Docket Number 50-346
License Number NPF-3
Serial Number 1691
Attachment 3
Page 1

TOLEDO EDISON COMPANY

DAVIS-BESSE UNIT 1

CORE OPERATING LIMITS REPORT

Figure 3.1-2a Regulating Group Position Limits,
 0 to 325± 10 EFPD, Four RC Pumps --
 Davis-Besse 1, Cycle 6

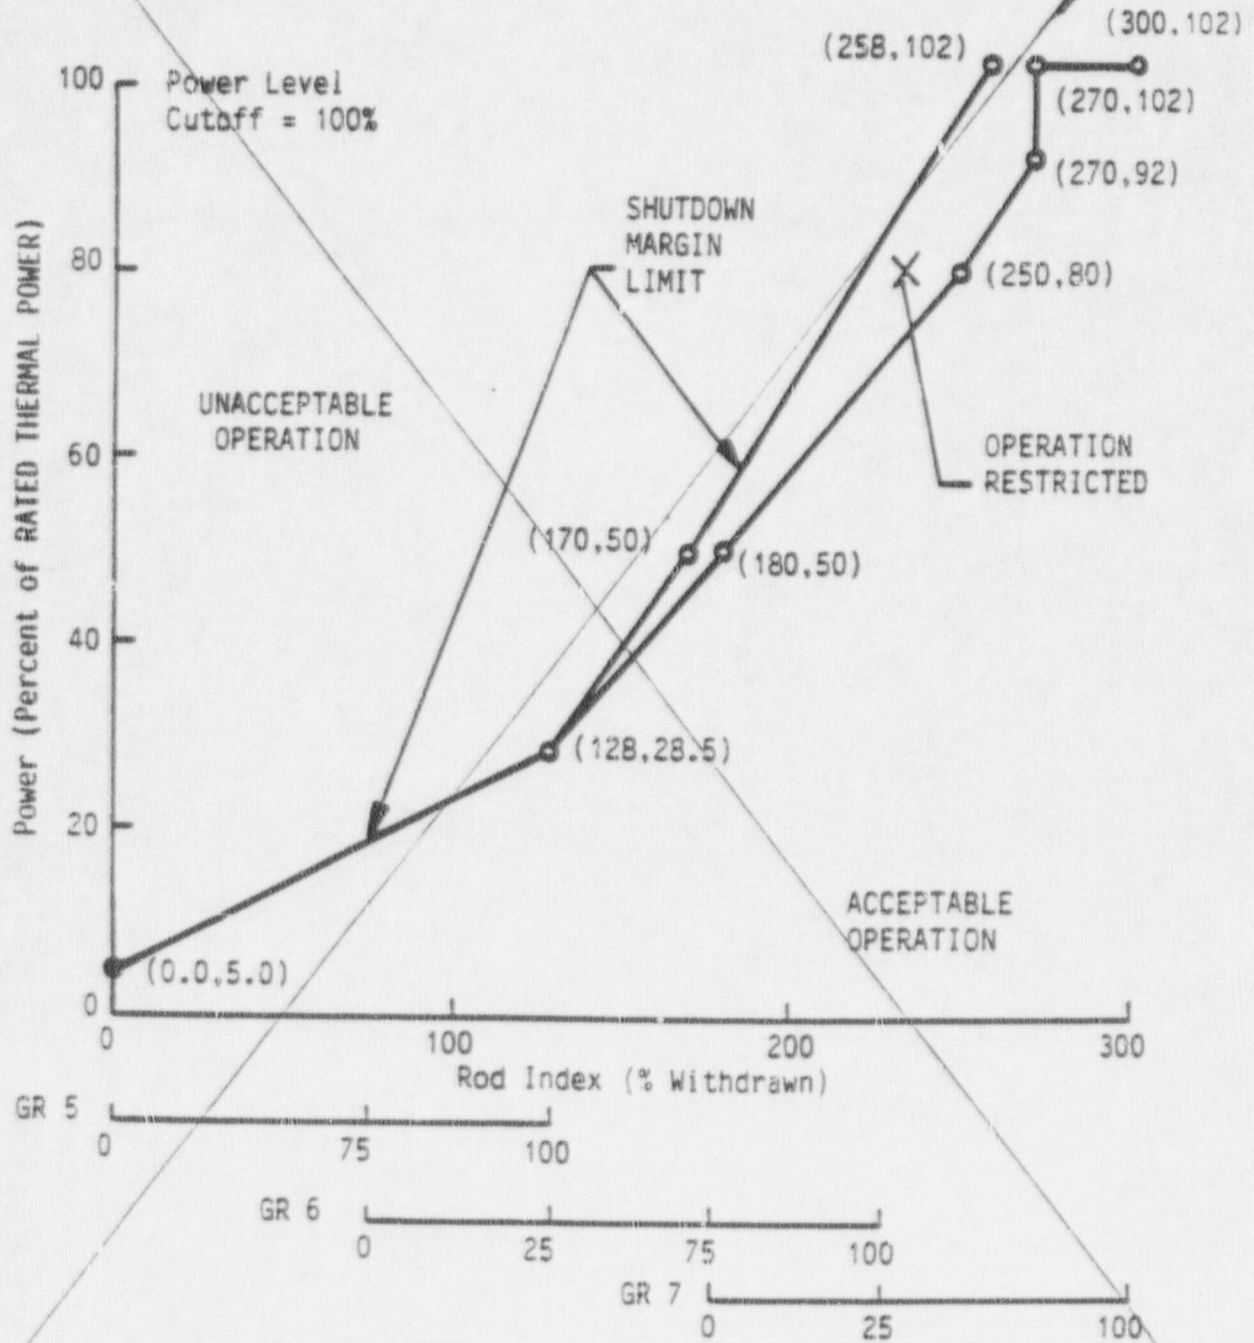
3.1.3.6 The regulating rod groups shall be limited in physical insertion as shown on Figures 3.1-2a, and -2b, 3.1-3a, and -3b. A rod group overlap of 25.5% shall be maintained between sequential withdrawn groups 5, 6 and 7, positioned within the acceptable operating limits for regulating rod position provided in the CORE OPERATING LIMITS REPORT.

DELETED

Figure 3.1-2b Regulating Group Position Limits After
 325± 10 EFPD, Four RC pumps, APSRs
 Withdrawn -- Davis-Besse 1, Cycle 6

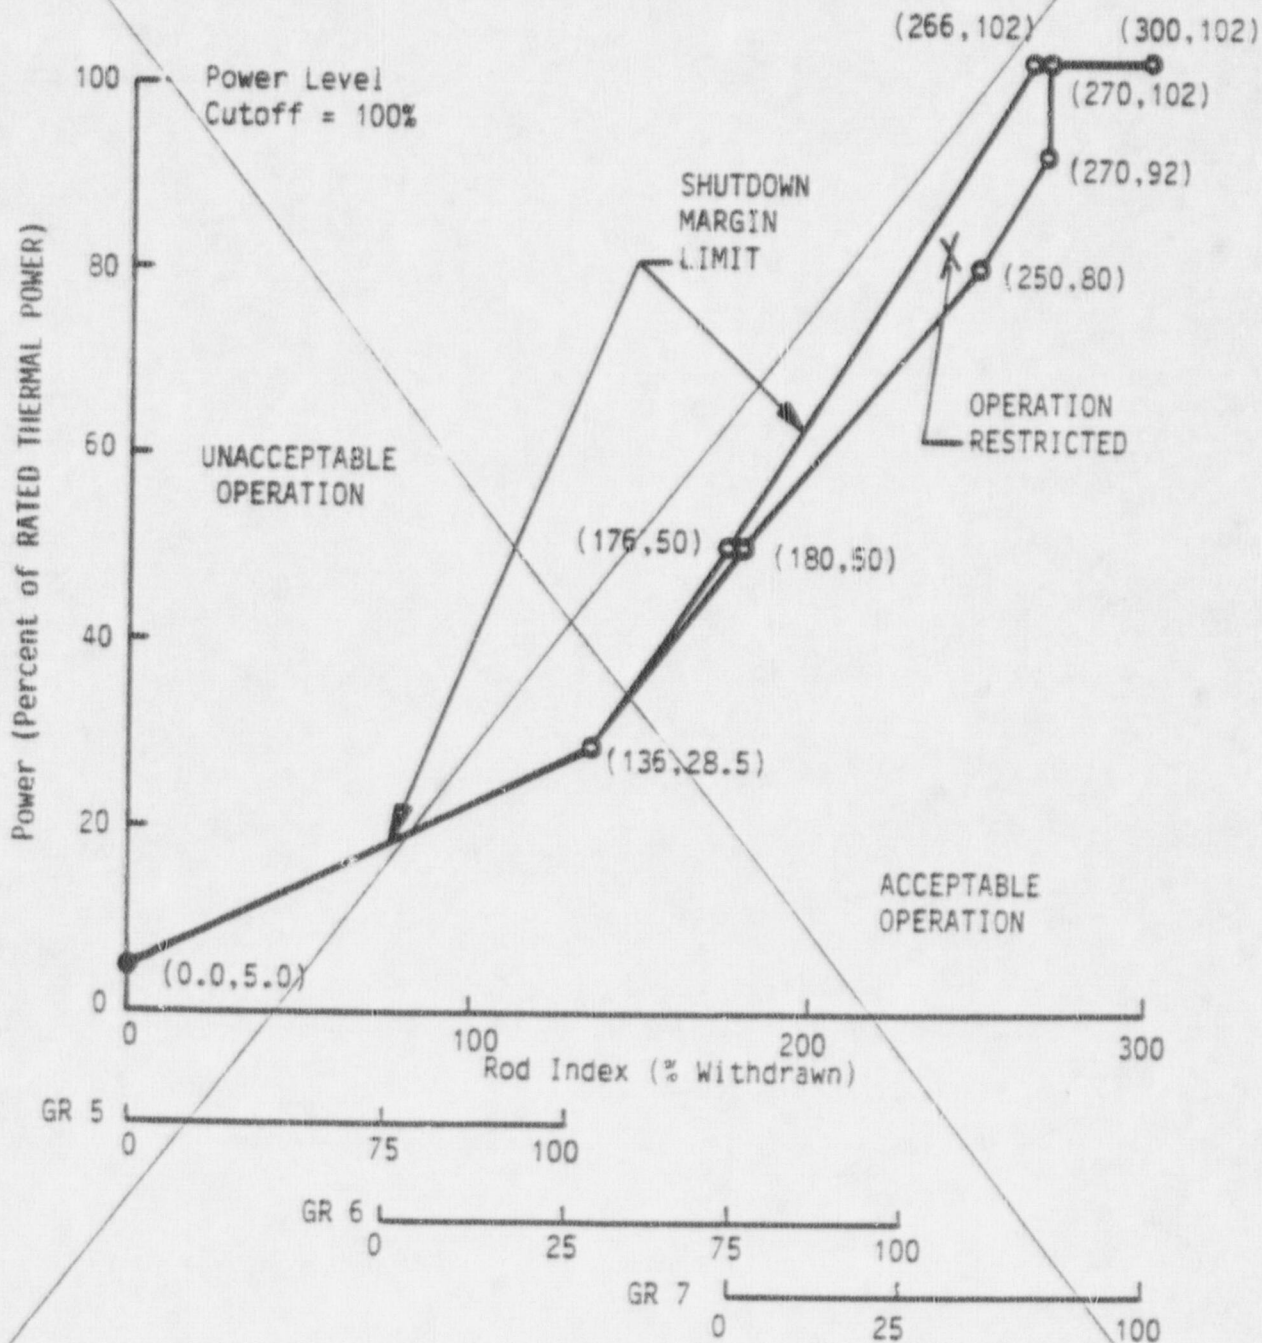
DELETED

Figure 3.1-3a Regulating Group Position Limits,
 0 to 325 ± 10 EFPD, Three RC Pumps --
 Davis-Besse 1, Cycle 6

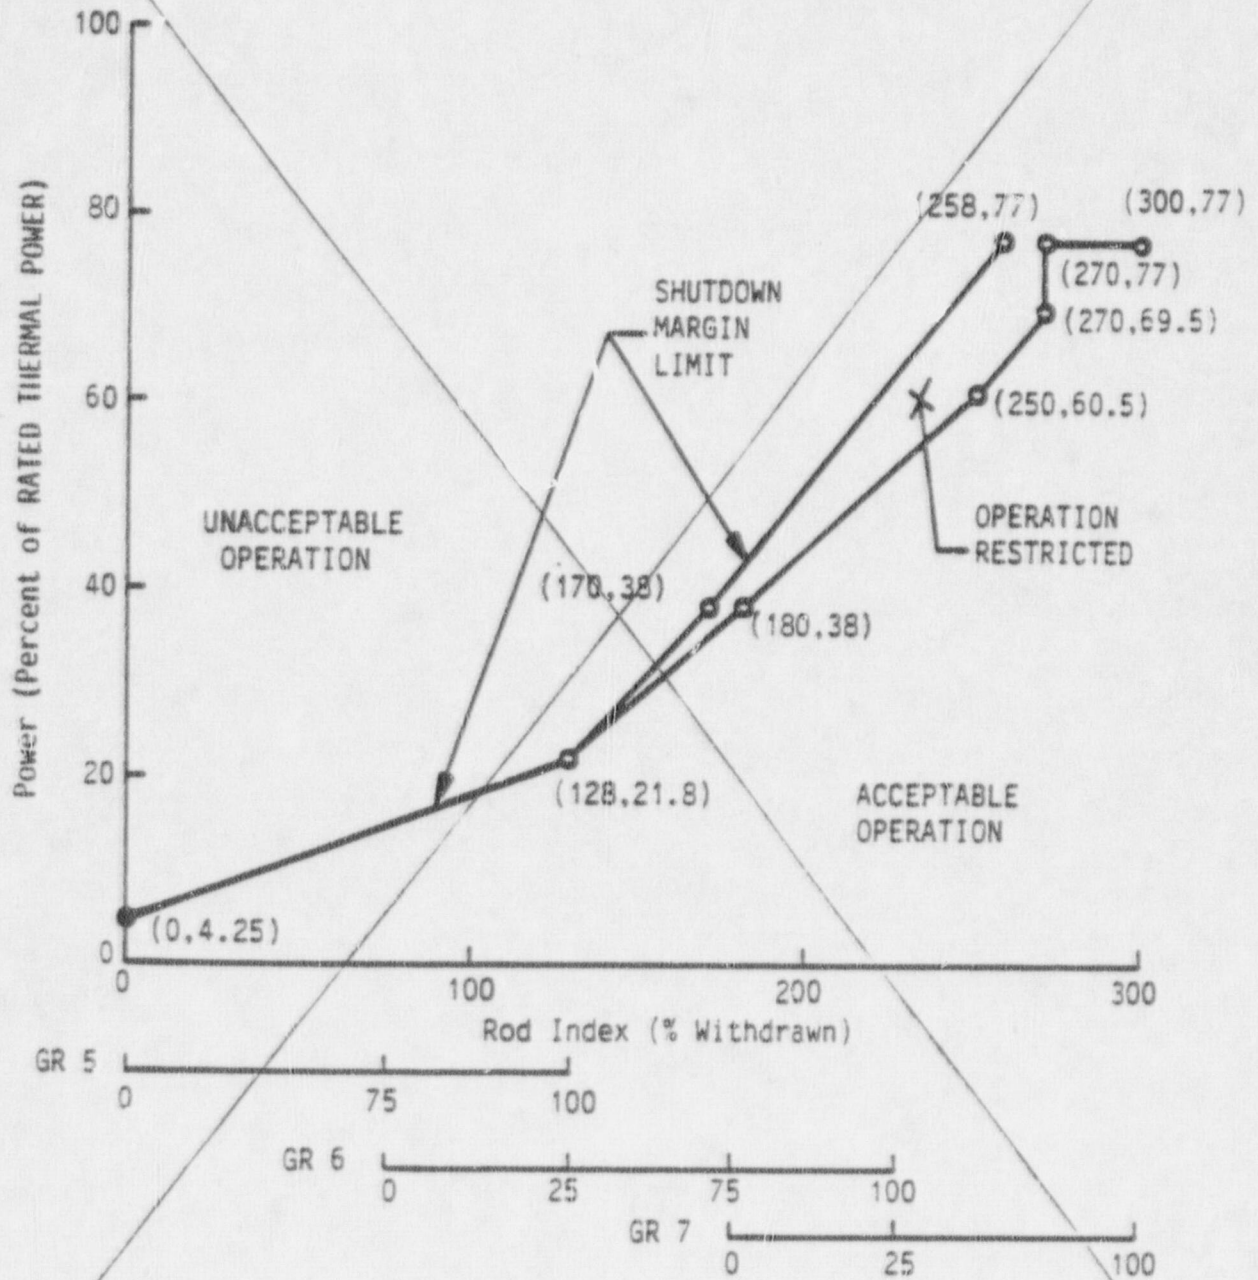
DELETED

Figure 3.1-3b Regulating Group Position Limits
 After 325 ± 10 EFPD, Three RC Pumps,
 APSRs Withdrawn -- Davis-Besse 1,
 Cycle 6

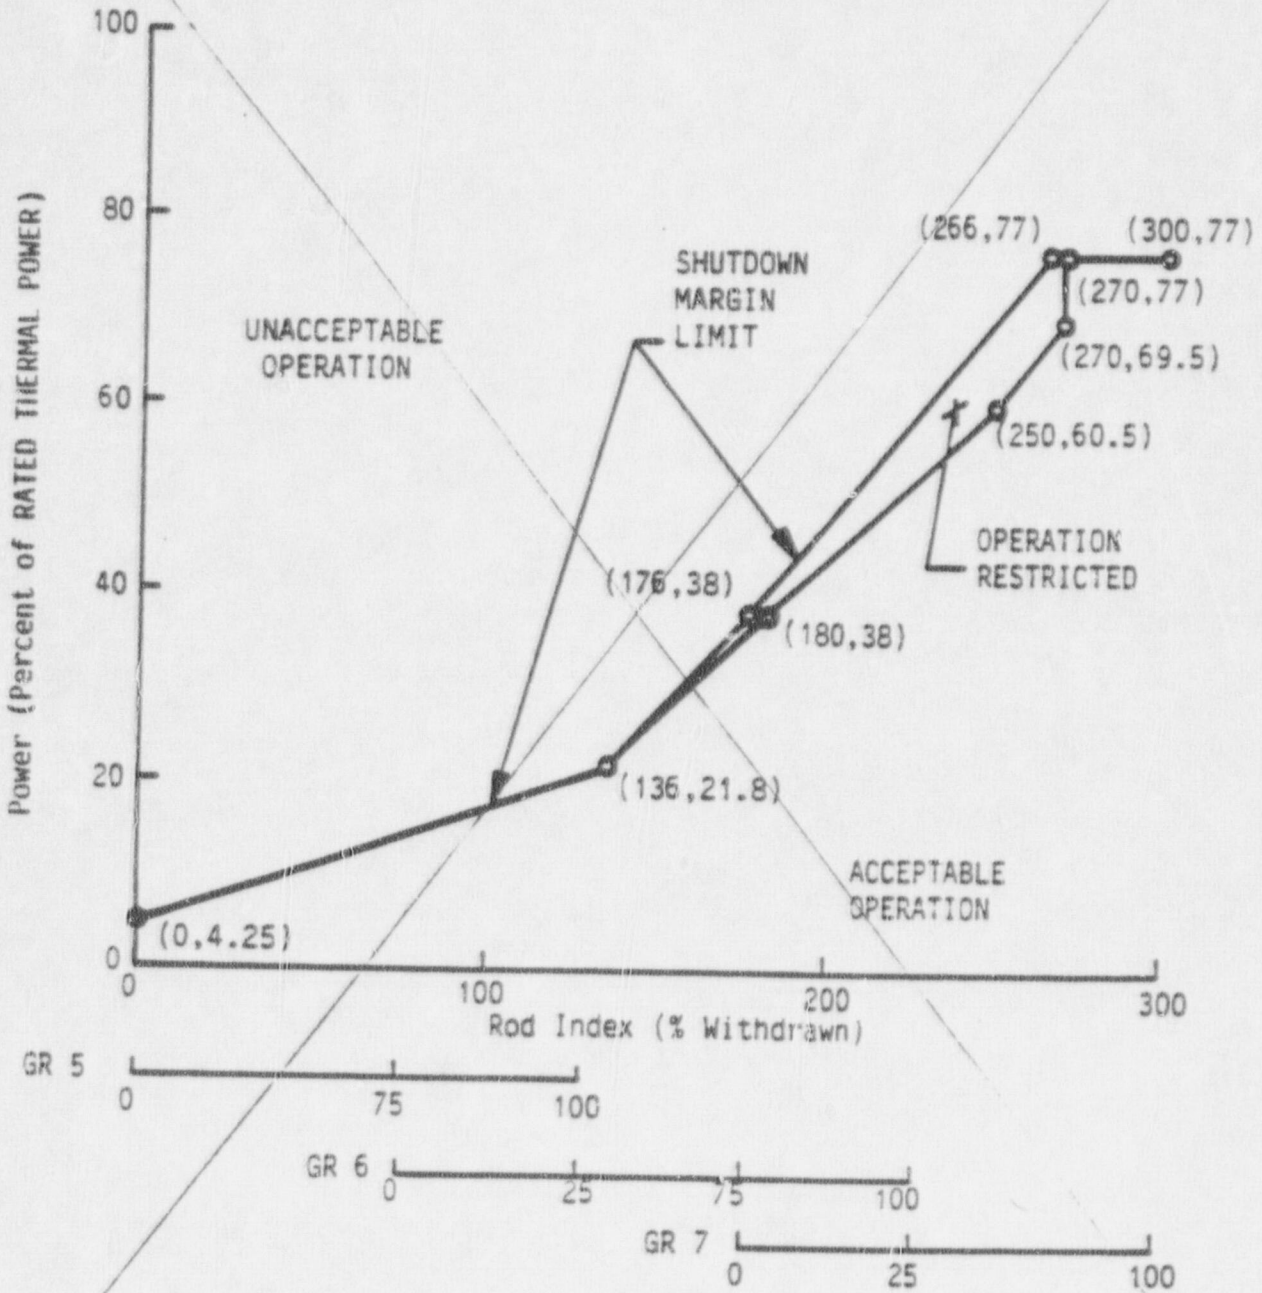
DELETED

Figure 3.1-4 Control Rod Core Locations and Group Assignments --
 Davis-Besse 1, Cycle 6

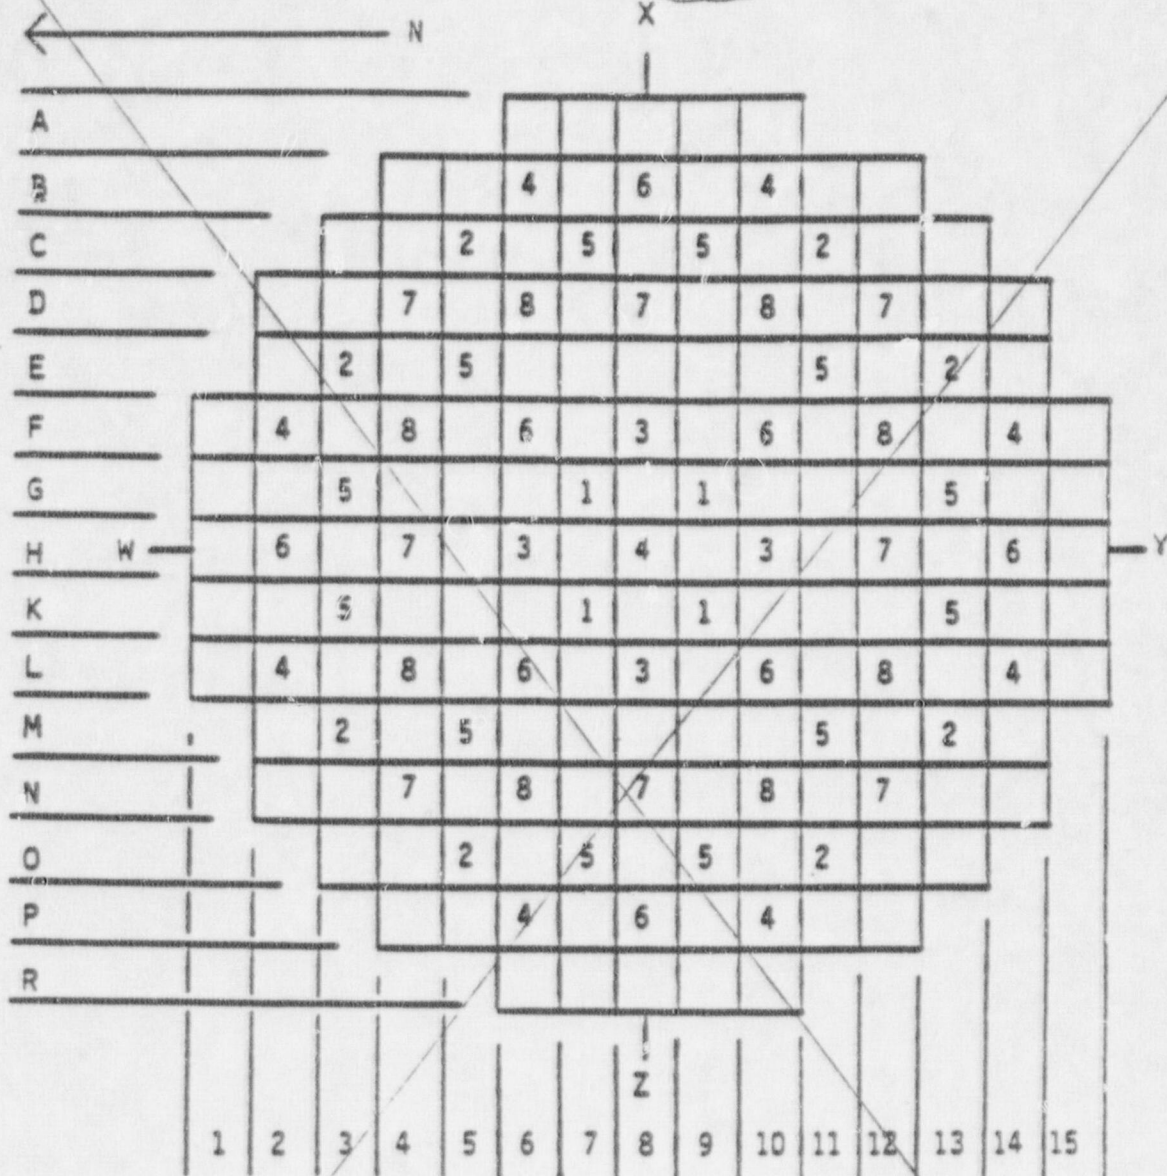
3.1.3.7 Each control rod (^{assembly} safety, ^{location} regulating and APSR) shall be programmed to operate in the core ^{position} and rod group specified in Figure 3.1-4, the CORE OPERATING LIMITS REPORT.

DELETED

Figure 3.1-5a APSR Position Limits, 0 to 325± 10 EFPD,
Four RC Pumps -- Davis-Besse 1, Cycle 6

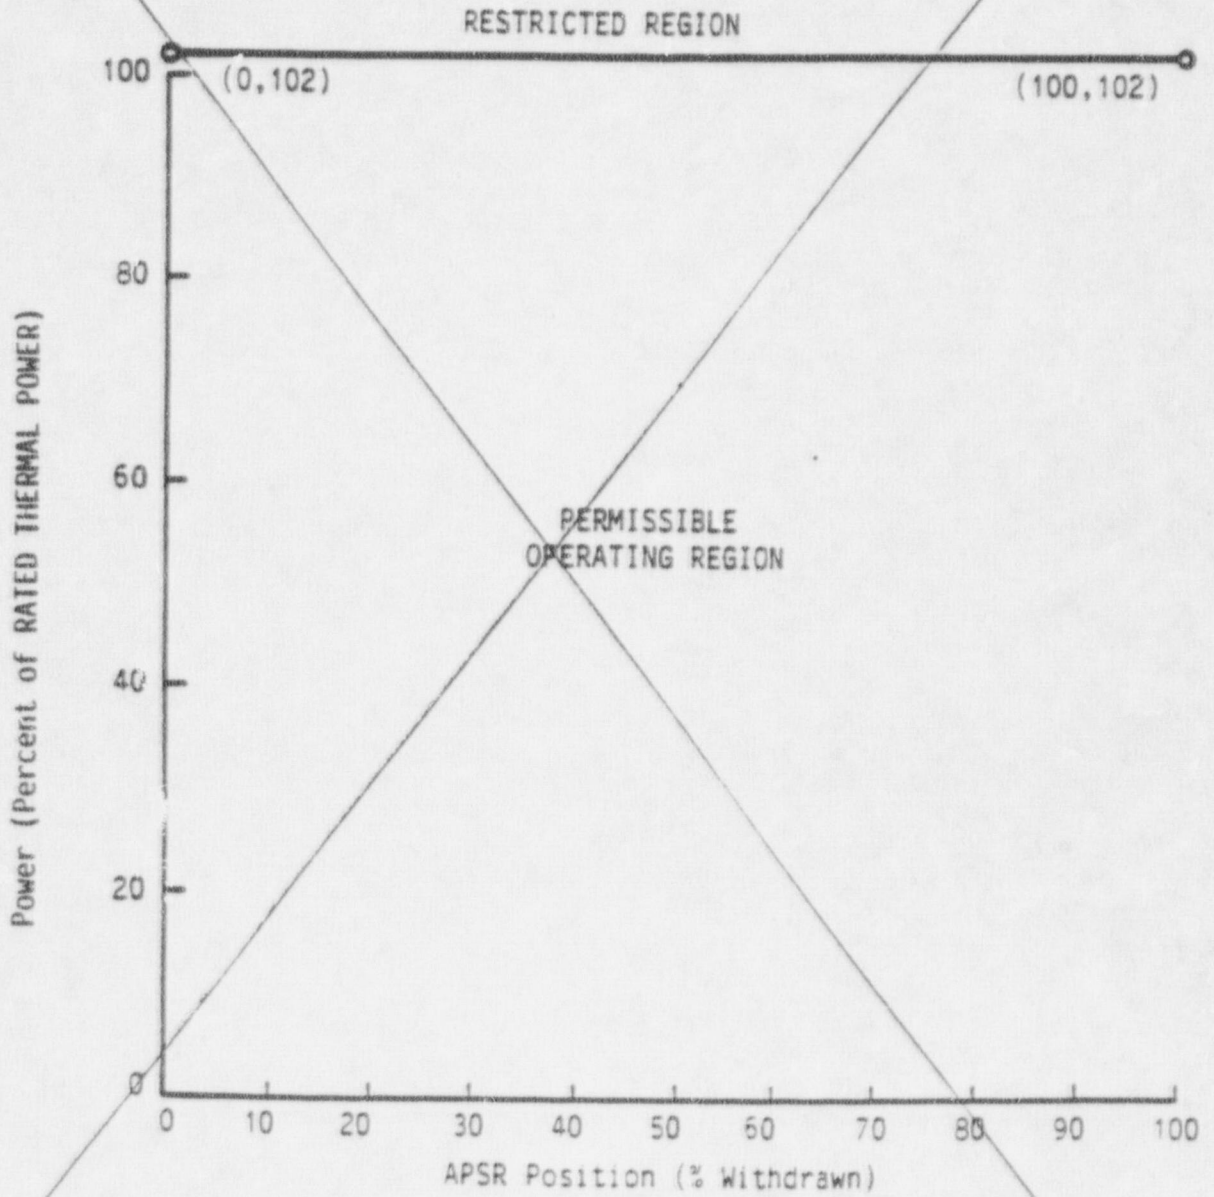
3.1.3.9 The axial power shaping rod group shall be limited in physical insertion as shown on Figures 3.1-5a, 5b, and 5c within the acceptable operating limits for axial power shaping rod position specified in the CORE OPERATING LIMITS REPORT

DELETED

Figure 3.1-5b APSR Position Limits After
325± 10 EFPD, Three or Four RC
Pumps, APSRs Withdrawn --
Davis-Besse 1, Cycle 6

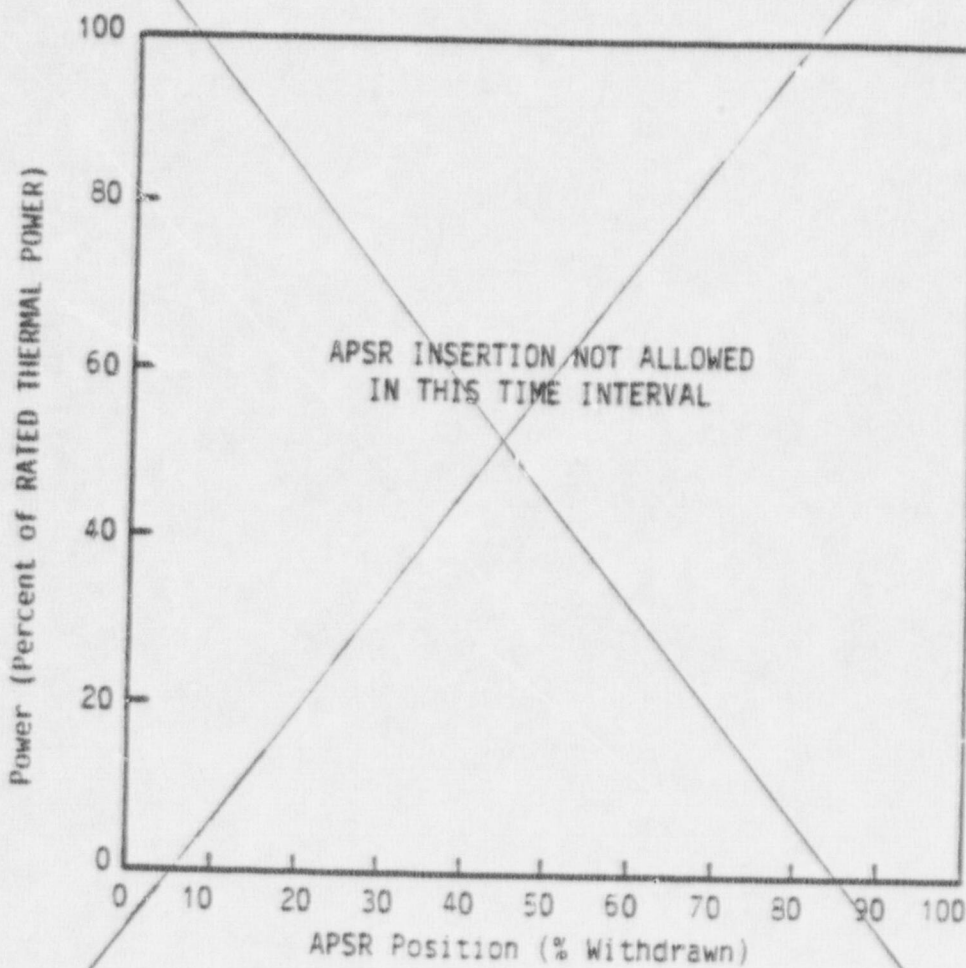
DELETED
